GLAMORGAN/SPRING BAY COUNCIL
NOTICE OF PROPOSED DEVELOPMENT

SITE: **1 Russell Street, Orford**
CT 159588/15

PROPOSAL: **Dwelling**

RESPONSE TO REQUEST FOR FURTHER INFORMATION DA 2026/126 – 1 Russell Street, Orford (CT 159588/15)

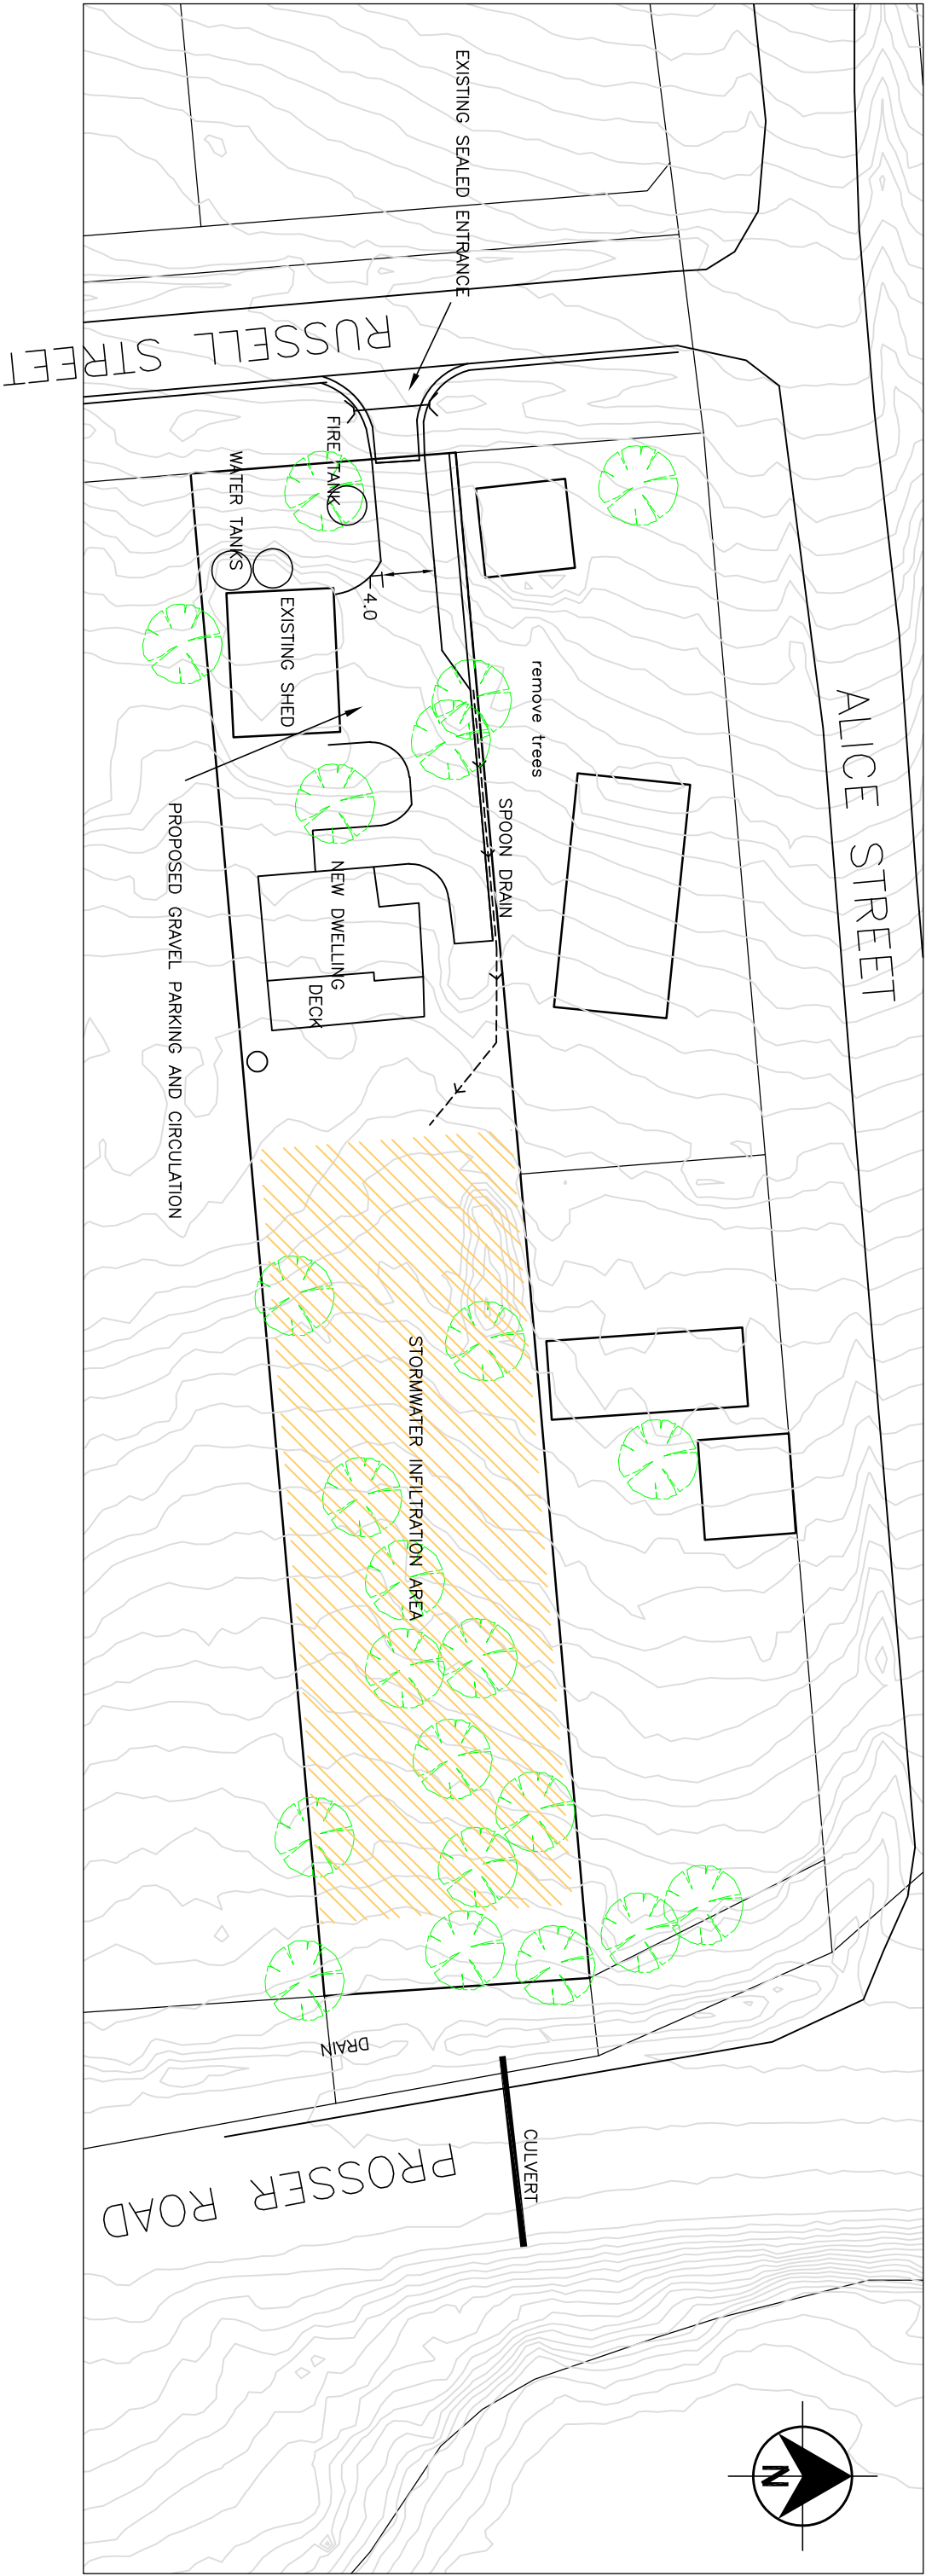
Provide an amended plan detailing the proposed construction materials for the access way, driveway, parking and manoeuvring areas, and demonstrating how stormwater runoff will be captured and managed.

The Stormwater Management drawing (Drawing 26555-01) has been updated to Rev and now shows:

- Stormwater from the driveway, parking and manoeuvring areas is managed as follows:
 - o runoff from the driveway and parking sheds as sheet flow off the gravel pavement to grassed and vegetated swale drain on west side of the driveway, avoiding concentration of flows and erosion of gravel;

- **Drainage:** runoff leaves the pavement as sheet flow to vegetated ground and is retained on site within the stormwater infiltration area, as described in item 1 (a) above. Crossfall prevents water ponding on or scouring the pavement.

- **Sediment and debris:** as the pavement drains into the site, runoff does not carry sediment to Russell Street. The sealed crossover between the carriageway and the property boundary separates the gravel pavement from the road, allowing loose material to drop from vehicle tyres before they reach Russell Street, and the culverted crossover keeps the roadside table drain clear. During construction, a single stabilised entry/exit point and wheel-cleaning measures will be provided, consistent with the soil and water management notes on the submitted site plans (iKonik Designs, SB-26120705).
